**MINUTES OF TECHNICAL REVIEW COMMITTEE (TRC)
AND PUBLIC MEETING
AUGUST 4, 1993**

SUBJECT: Technical Review Committee and Public Meeting - August 4, 1993
Installation Restoration Study
Naval Submarine Base - New London
Groton, Connecticut
Contract No.: N62472-88-C1294

FINAL ACTION MEMORANDUM FOR BUILDING 31

ATTACHMENT 2

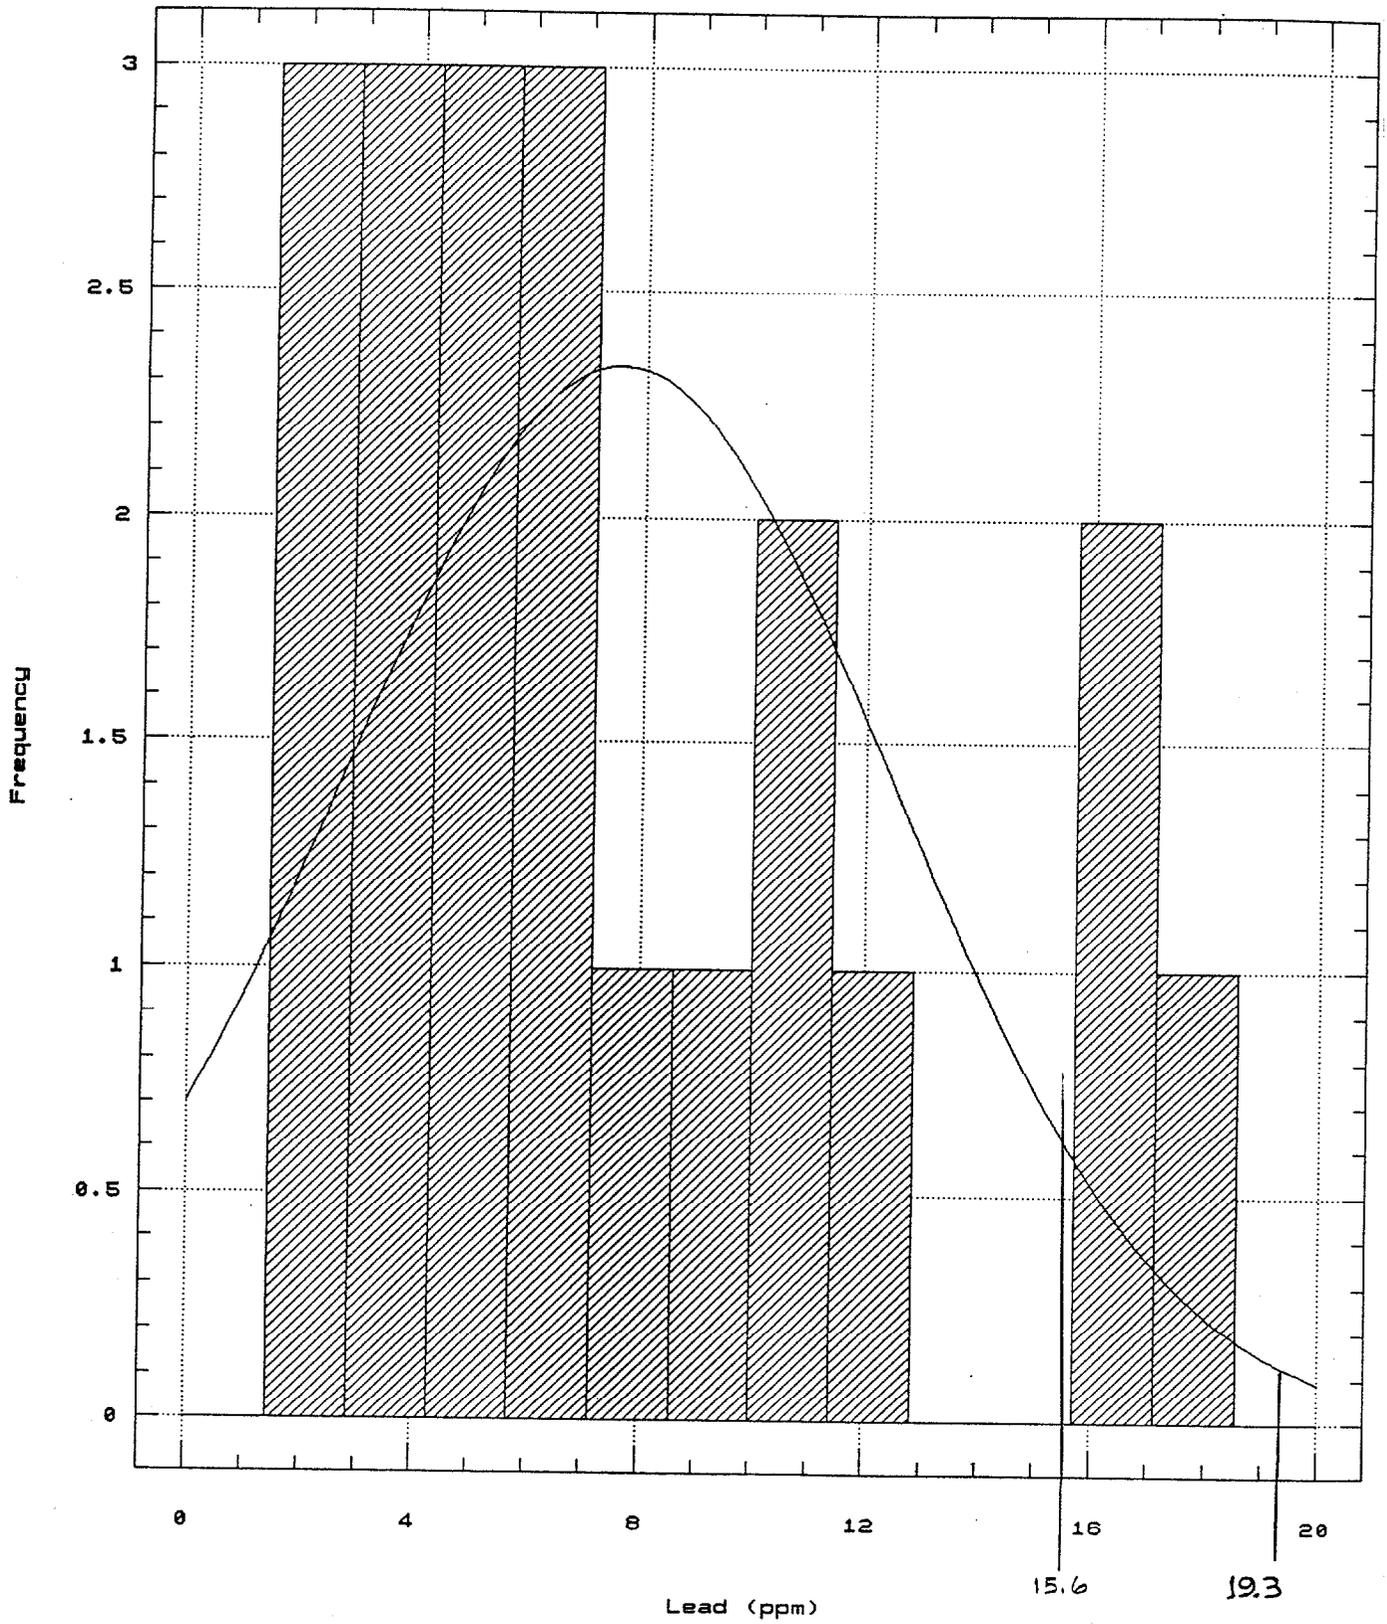
Comment: A comment was raised regarding a typographical error on the overhead transparency which is corrected in Attachment 2 of these minutes. The mean value for vanadium was incorrectly indicated as 250 ppm. The actual value is 25.0 ppm.
